1601 LeMoyne Ave Cuse Car Care, LLC project roadmap

<i>R-24-26</i>	<i>Staff Report – July 8, 2024</i>
<i>Application Type:</i>	Resubdivision
<i>Project Address:</i>	1601 Lemoyne Avenue (Tax Map ID: 004.-05-03.0), 1611 Lemoyne Avenue To City Line, (Tax Map ID: 004.-05-02.0), 1585 Lemoyne Avenue (Tax Map ID: 004.-05-04.1)
<i>Summary of Proposed Action:</i>	<p>The Applicant proposes to merge three lots (1601 Lemoyne Ave, 1611 Lemoyne Ave, and 1585 Lemoyne Ave) into one new lot. The parcels are also across with municipal boundary in the Town of Salina.</p> <p>The applicant intends to build a two-story addition to the existing 1 story car repair shop upon the approval of resubdivision</p> <p>New lot 4A (only the portion in the City of Syracuse): 0.57 Acres/25,003 SF</p>
<i>Owner/Applicant</i>	Michael Pierce, Cuse Car Care LLC (Owner) Jared McCormick, Daniel Manning-Architect, PLLC (Applicant)
<i>Existing Zone District:</i>	Mixed-Use Transition, MX-3 Zone District

<u>SP-24-09</u>	Staff Report – July 8, 2024
Application Type:	Special Use Permit
Project Address:	1601 Lemoyne Avenue (Tax Map ID: 004.-05-03.0), 1611 Lemoyne Avenue To City Line, (Tax Map ID: 004.-05-02.0), 1585 Lemoyne Aven

SHEET NUMBER
L-1

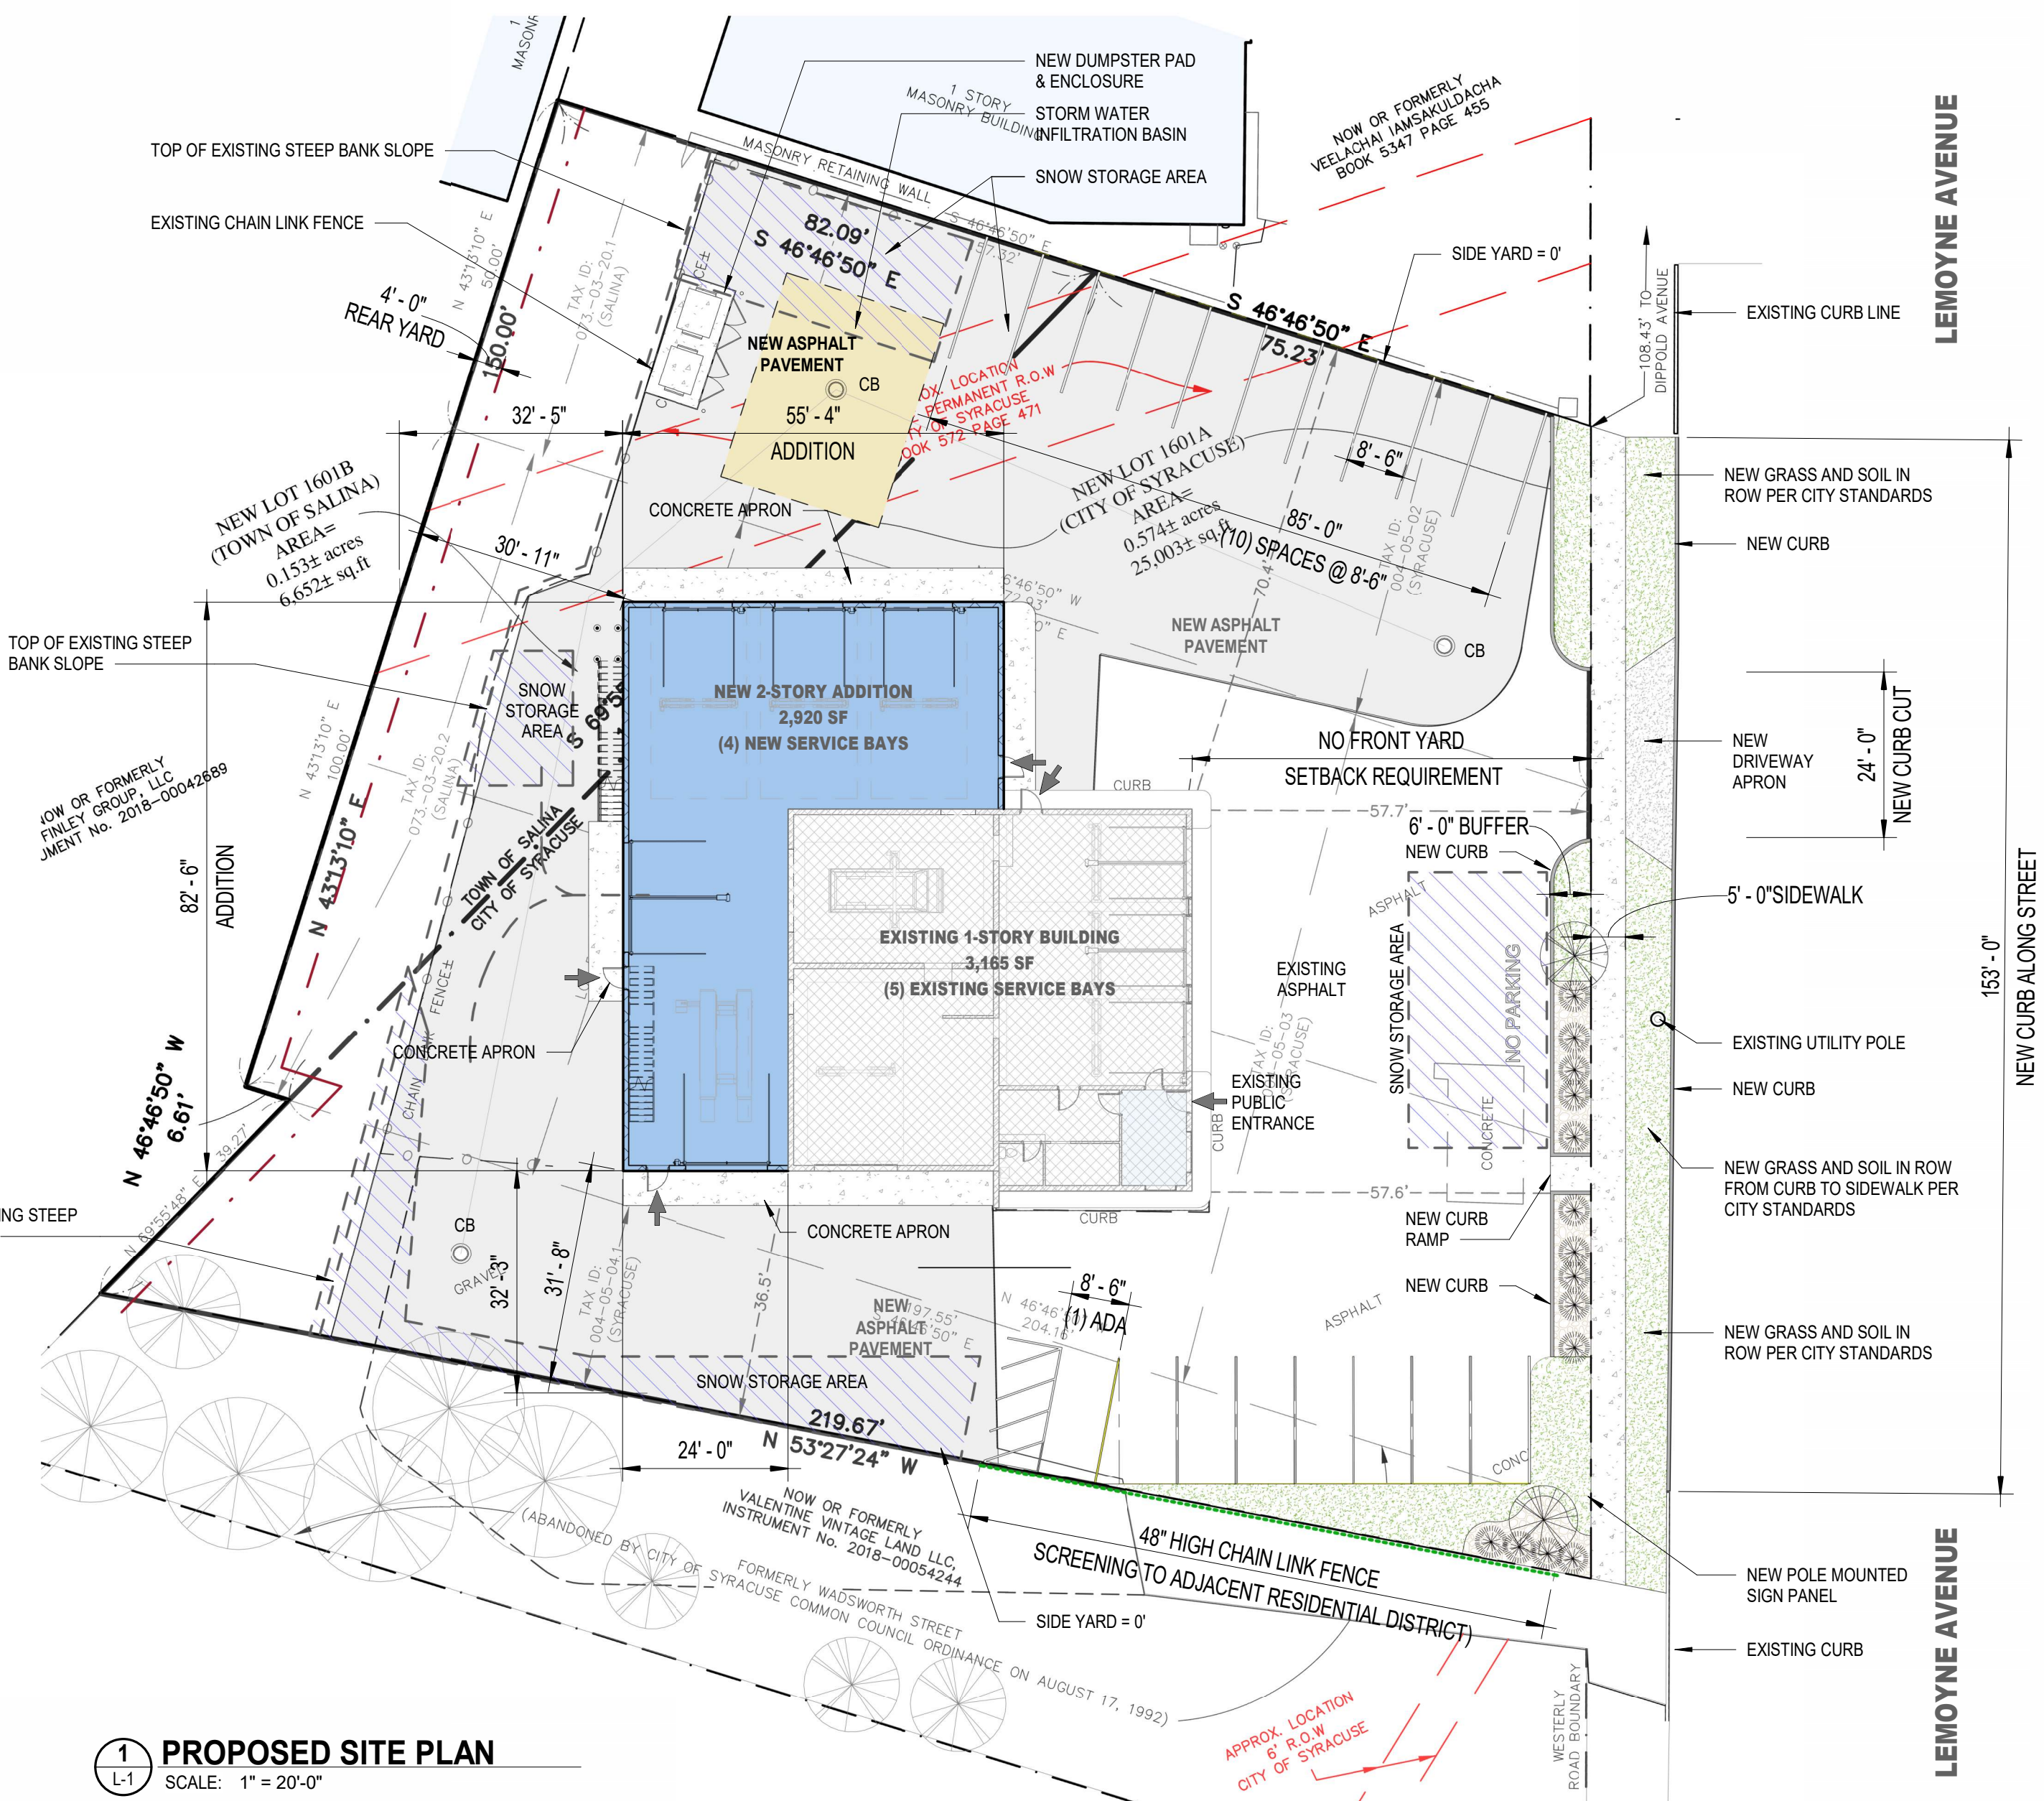
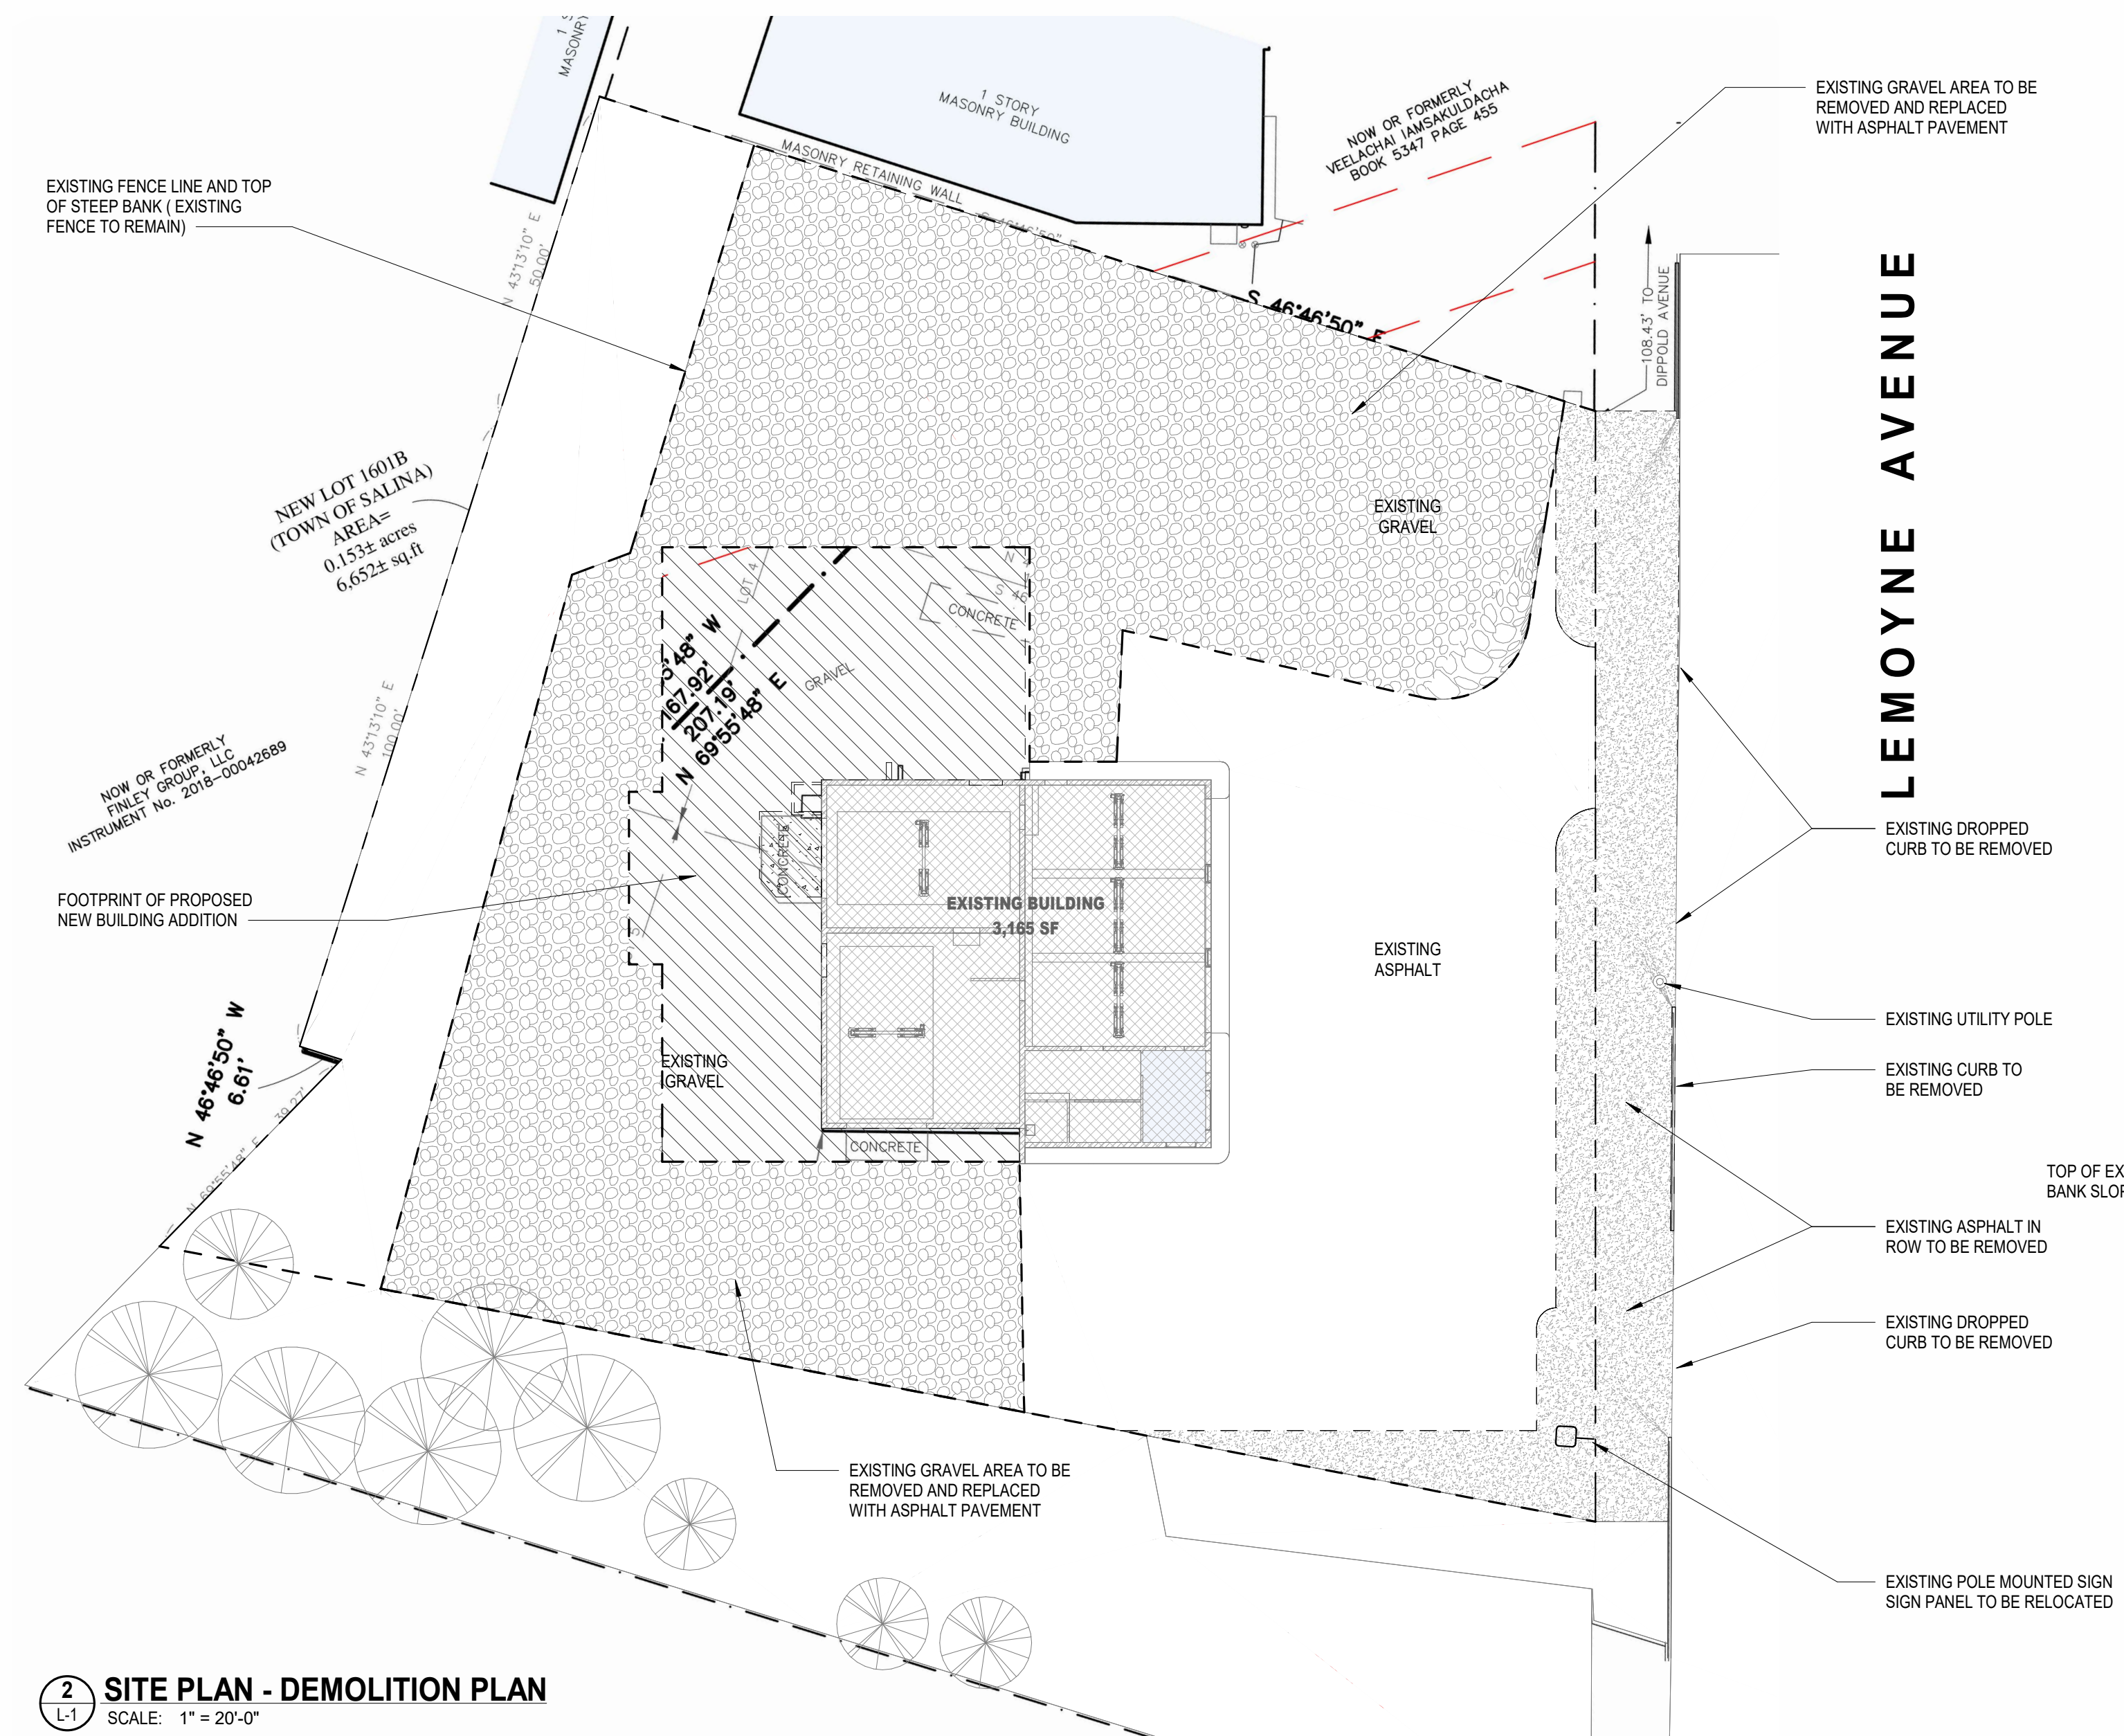
- WHEREAS, per the Site Plans, the applicant is proposing construction of a 2,920 sf 2-story addition to the northeastern and northwestern sides of the existing building which will allow construction of four new service bays in addition to the existing five bays, second floor offices, breakroom, and storage; gravel will be replaced with new asphalt, a dumpster enclosure constructed, and striping of 17 parking spaces along the southwestern and northeastern site boundaries; the Site Plans do not depict any changes in access to the site, plantings, or increase in permeable surface; and

will not result in additional stormwater; the Site Plan depicts 3 catch basins located in the parking lot; and

1. The applicant is required to coordinate with the Onondaga County Department of Transportation regarding access plans and establish formal driveway access to LeMoyne Avenue in conformance with commercial driveway standards. The municipality must ensure any mitigation as may be determined by the Department is reflected on the project plans prior to, or as a condition of, municipal approval.
2. The applicant and City must coordinate a multi-municipal review of the proposed project with the Town of Salina.
3. The applicant and municipality are encouraged to improve appearance of the

site while improving stormwater conditions by adding landscaping and plantings along the road frontage and parcel boundaries, adding bioswales and planting islands, and/or utilizing permeable pavement on site.

1. The applicant is required to coordinate with the Onondaga County Department of Transportation regarding access plans and establish formal driveway access to LeMoyne Avenue in conformance with commercial driveway standards. The municipality must ensure any mitigation as may be determined by the Department is reflected on the project plans prior to, or as a condition of, municipal approval.
2. The applicant and City must coordinate a multi-municipal review of the proposed Site Plan with the Town of Salina.

The applicant and municipality are encouraged to improve appearance of the site while improving stormwater conditions by adding landscaping and plantings along the road frontage and parcel boundaries, adding bioswales and planting islands, and/or utilizing permeable pavement on site.

Approval	Status	Status Date	Reviewer	Comments
DPW - Transportation Planner	Conditionally Approved	06/25/2024	Neil Milcarek-Burke	<p>Revised plans address previous comments.</p> <ul style="list-style-type: none"> - Applicant to ensure that cross access with neighboring parcels is restricted unless agreement in place, and parking areas along southern property line incorporate bollards or other fixed objects (no wheel stops) to prevent parking on grass. <p>Revised plans required. Current site is hazardous to pedestrians and other traveling public due to lack of channelization for vehicle ingress/egress at a high-volume signalized intersection of an Arterial and Major Collector.</p> <ul style="list-style-type: none"> - Parcel to conform to 24' max width curb-cut, current site plan shows ~120' feet total curb-cut. All other areas outside typical 24' opening to be restored to full reveal granite curb. - Concrete sidewalk required required across Lemoyne Ave frontage, including across driveway. Walk to be located at property line. - Asphalt is not a permissible ground cover material in the ROW, all asphalt in the ROW is to be removed and area restored to topsoil & grass, outside of revised driveway opening. Area between sidewalk and curbline should be grass, and incorporate any requirements per Forestry Department. - Parking area/lot frontage to incorporate a guide rail or other fixed vertical objects (no wheel stops), other than

- Parking area to be curbed/incorporate fixed vertical objects (no wheel stops) along all sides.
- Parking area to incorporate greenspace buffer, 5' or greater along entirety of Lemoyne ave frontage outside of driveway opening, measured inwards from property line. To include perirenal plant material/trees/etc.
- Planting plan required, grading/drainage plan may impact/increase buffer requirements.
- ADA compliant walkway to/from the main entrance and public ROW/sidewalk required, typically aligned with loading area of accessible parking stalls.

DPW - Sanitation & Sewers	On Hold	04/17/2024	Vinny Esposito	<p>please provide a drainage plan, The site will be nearly 100% impervious as per plan. Storm water must be mediated to an extent, dry wells or re-charge trenches. Also the sewer in the 20' ROW must be located precisely as I believe this is a 30" storm sewer.</p>
DPW - Traffic Control	Conditionally	04/23/2024	Charles	4.23.24 Conditionally Approved.

Approved		Gafrancesco	No sidewalk closures or obstructions or road or lane closures will be allowed as part of this work unless accompanied by MUTCD compliant detour.
Zoning Planner	On Hold	04/17/2024	Haohui Pan	Updated plan needs: The east side of the building that abutting the adjacent Residential Zone shall be fenced.
Engineering - Stormwater (SWPPP)	Conditionally Approved	04/25/2024	Mirza Malkoc	<ul style="list-style-type: none"> • All construction in the R.O.W. will require a road cut permit, all construction in the R.O.W. to be per City standards and specifications. • Complete set of the stamped engineering site plans with specific details are required to complete a detailed project permit review. • Designer shall clearly indicate on the site plans how much soil disturbance this project will create. If the soil disturbance is over 10,000sf then a SWPPP is required but if the soil disturbance is less than 10,000sf then the designer need to do some improvements to the site by capturing the stormwater sheet flow and treating it before discharging it to the City's ROW. • Proposed grading shall be graded to prevent stormwater sheet flow to adjoining properties & to the City R.O.W. • The Project is subject to Onondaga County's 1:1 offset. The City requires an offset plan & details for review. Applicant shall submit sanitary flow data to the Engineering Department, the determined offset plan then most likely will require Common Council Approval. • Onondaga County Plumbing Control shall review and approve the plans as well.
